Change Notice for DFR0868 V2.0

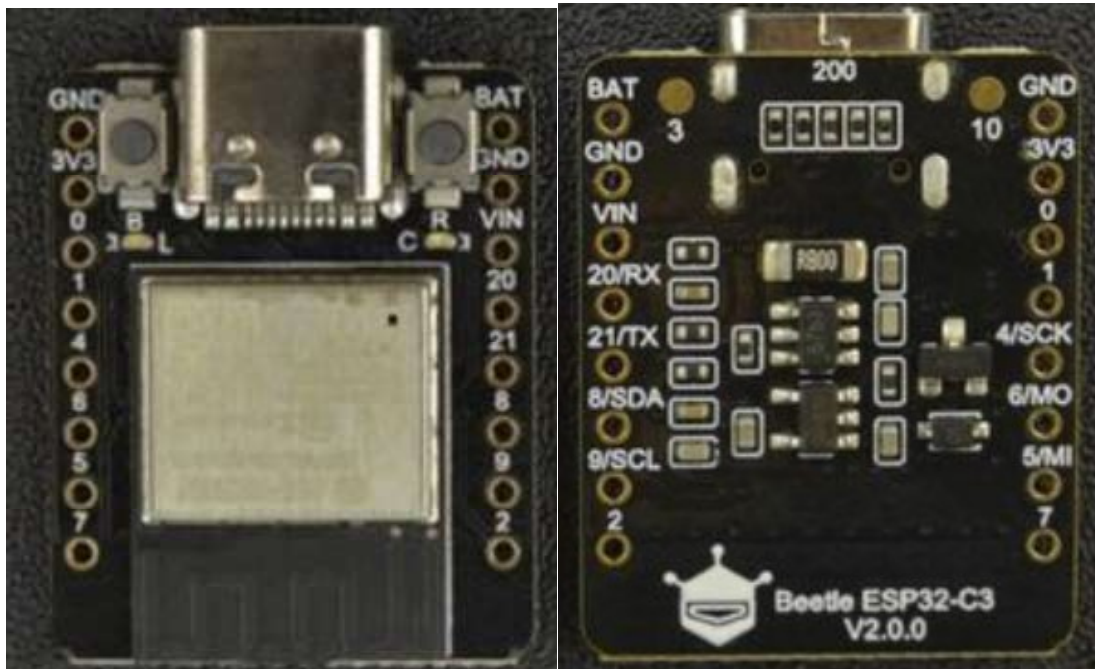
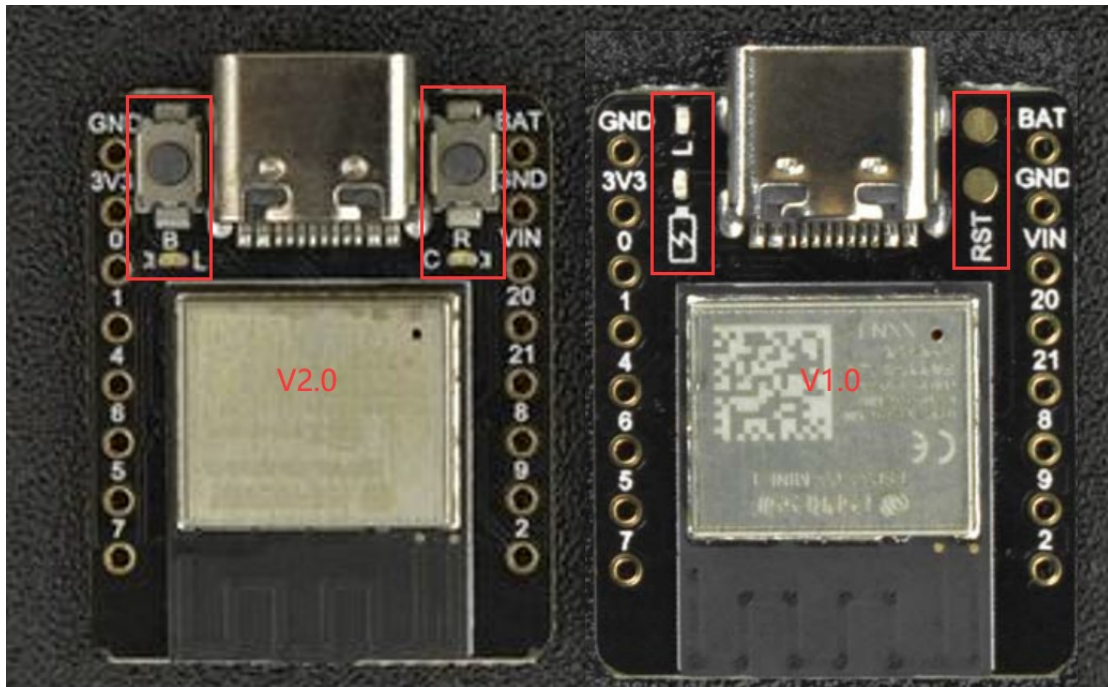
1. In version 2.0, BOOT and RST buttons have been added, and the position of the indicator lights has been changed as shown in the following diagram.
